Admin. approval of minor changes made to the EPC approved Site Plan to avoid existing utility lines that were not located correctly on the site survey (relocating dumpster enclosure); and to address constructability and durability concerns (minor adjustments to ext. facades).

EPC #20018-001760 / SI-2018-00223; City Council Hearing File # AC-19-2; SI-2019-00308

The purpose of this letter is to provide justification for the minor changes that have been made to the Environmental Planning Commission (EPC) approved Site Plan for the Singing Arrow Community Center located at 13200 Wenonah Avenue SE, in the Canada Village – Second Unit Subdivision in response to issues that have arisen during the construction of the project. The relevant project numbers for this project are: EPC Project #20018-001760/SI-2018-00223, City Council Public Hearing File #AC-19-2; and SI-2019-00308.

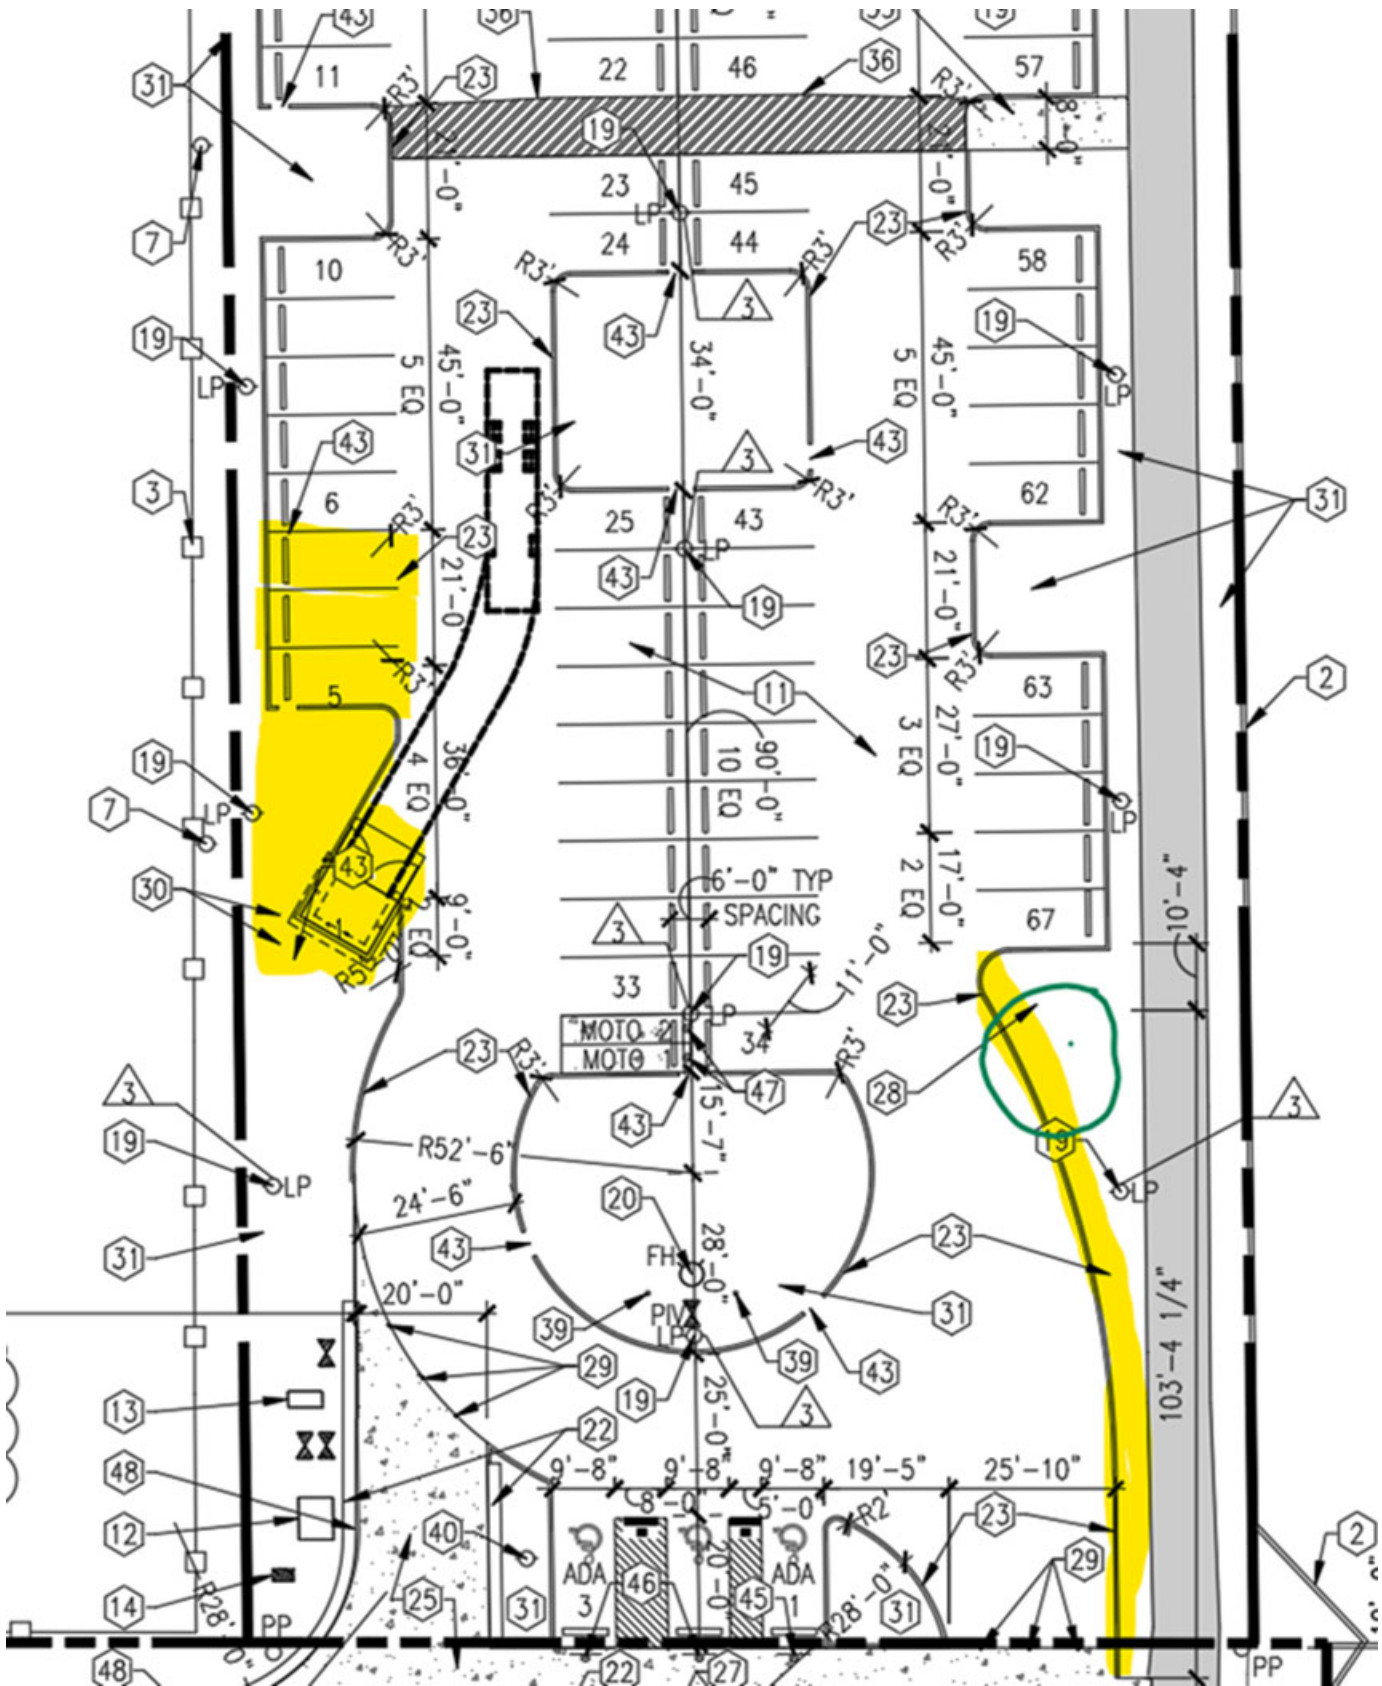
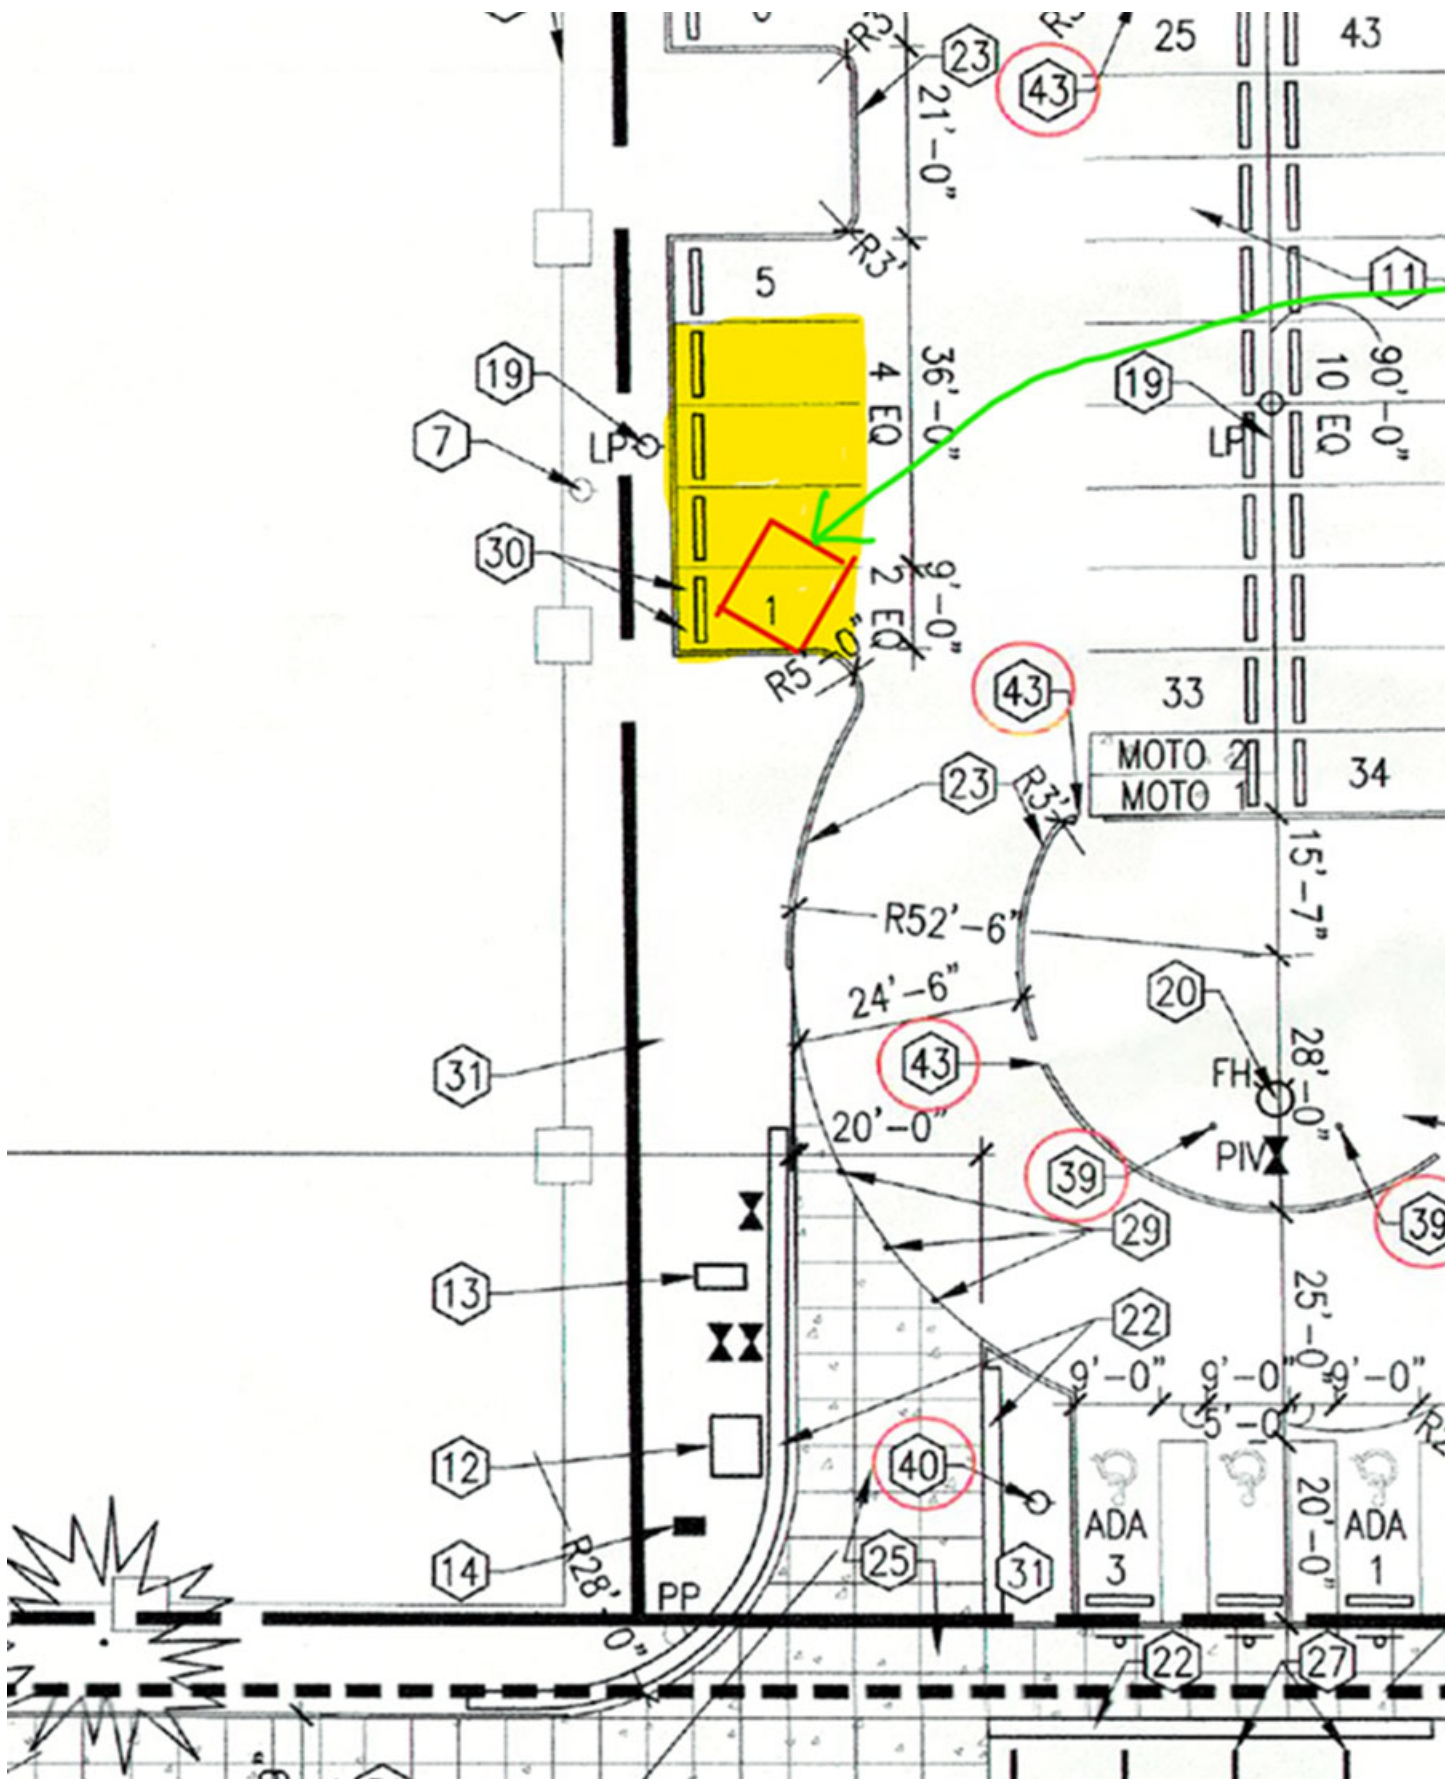
At this moment, our best option is to move the trash enclosure to the west side of the site. In this move, in order to not affect any of the necessary drainage that has been approved by hydrology, the trash enclosure would displace 2 parking spaces, and require that 3 parking spaces be shifted slightly north, switching places with the planter area.

See cropped view of the site plan below for reference. In yellow, I’ve shown the 4 spaces that will have to be removed or shifted to accommodate access for waste management.

I need to know if this proposed plan will be acceptable. Will we be required to update the approved TCL? What is the process for getting this change approved?

Attached you will find a site plan approved for access by the Solid Waste Department.

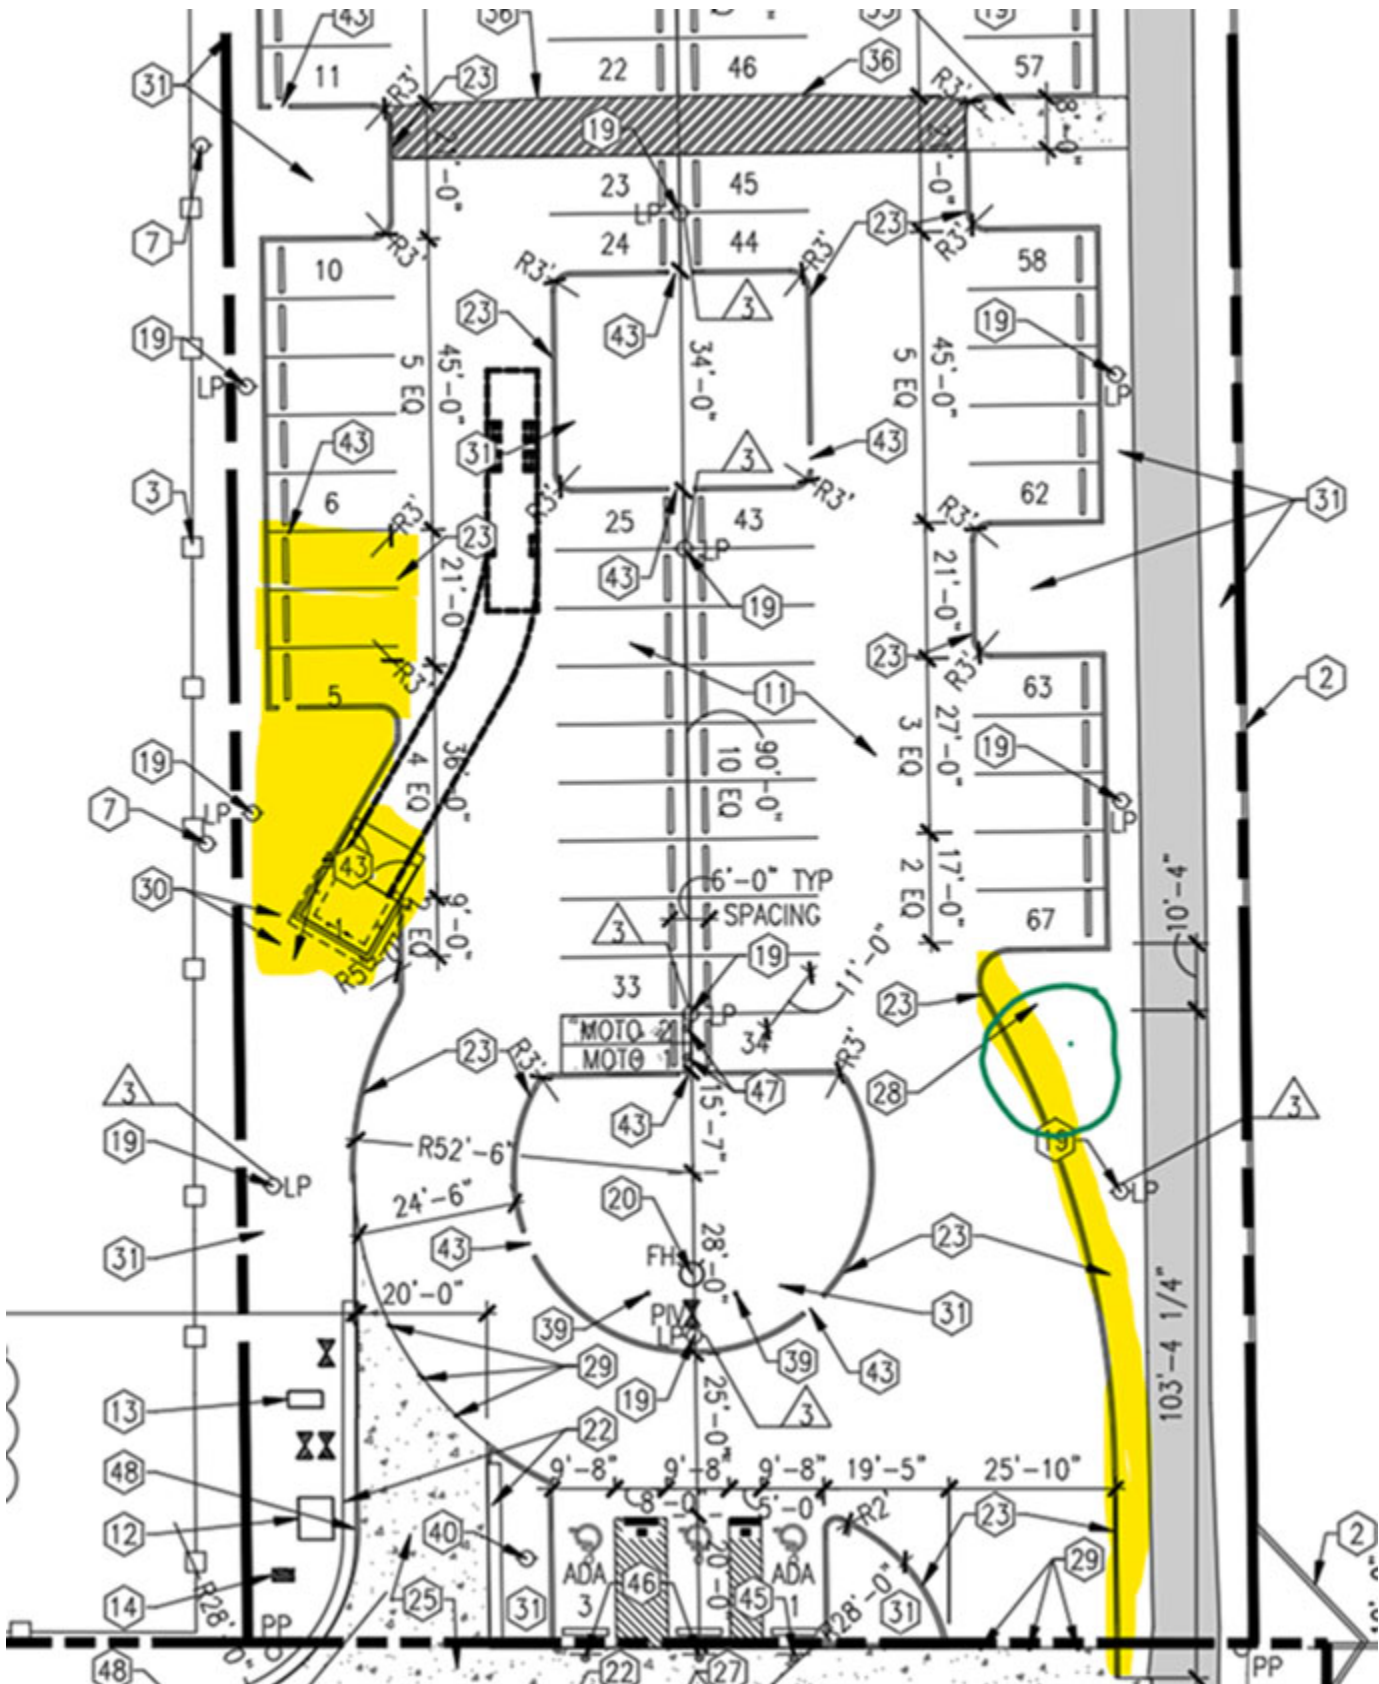
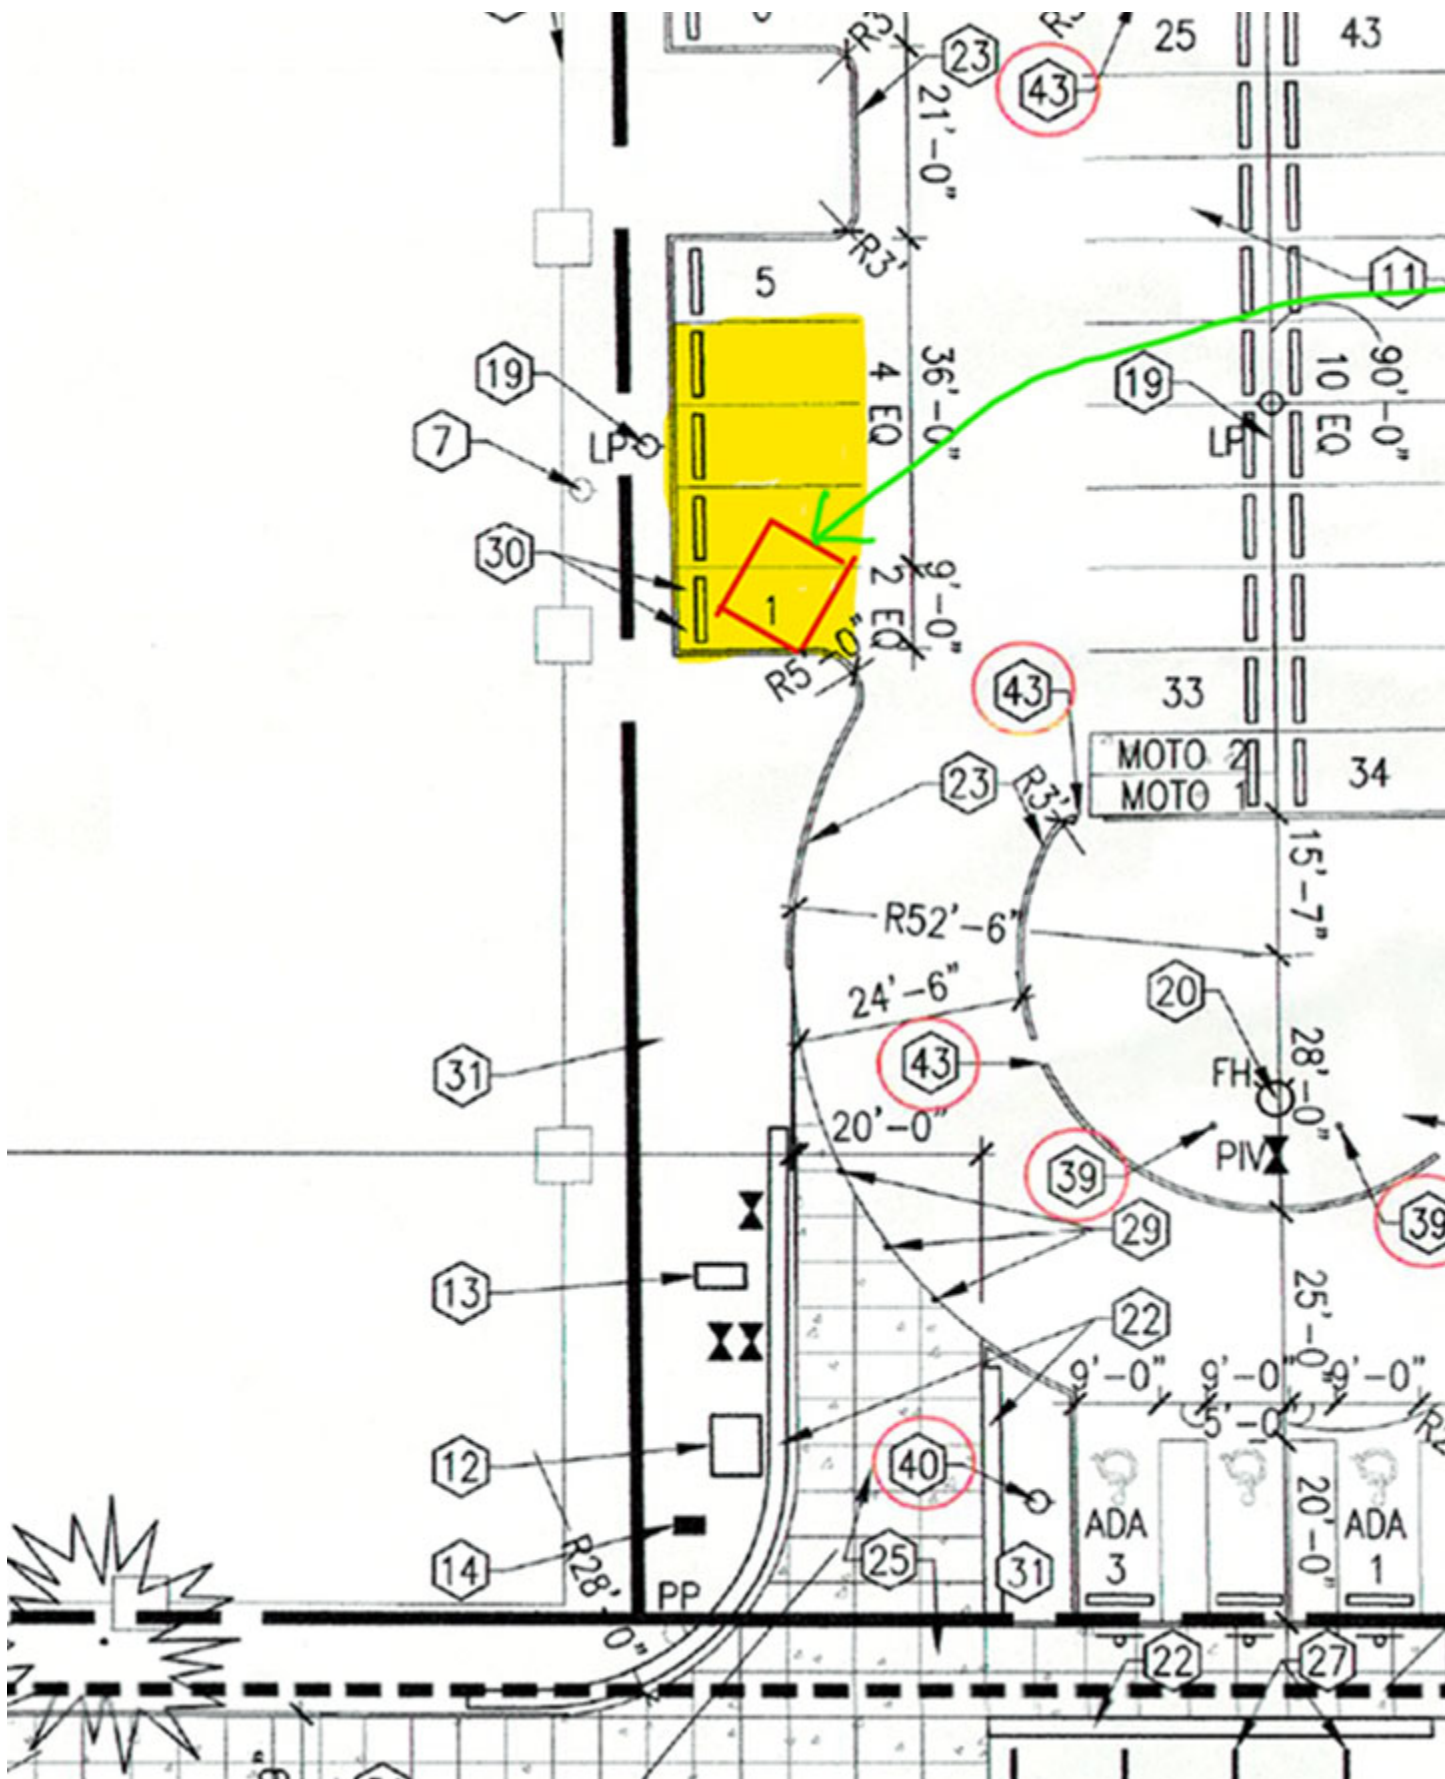
At this moment, our best option is to move the trash enclosure to the west side of the site. In this move, in order to not affect any of the necessary drainage that has been approved by hydrology, the trash enclosure would displace 2 parking spaces, and require that 3 parking spaces be shifted slightly north, switching places with the planter area.

See cropped view of the site plan below for reference. In yellow, I've shown the 4 spaces that will have to be removed or shifted to accommodate access for waste management.

I need to know if this proposed plan will be acceptable. Will we be required to update the approved TCL? What is the process for getting this change approved?
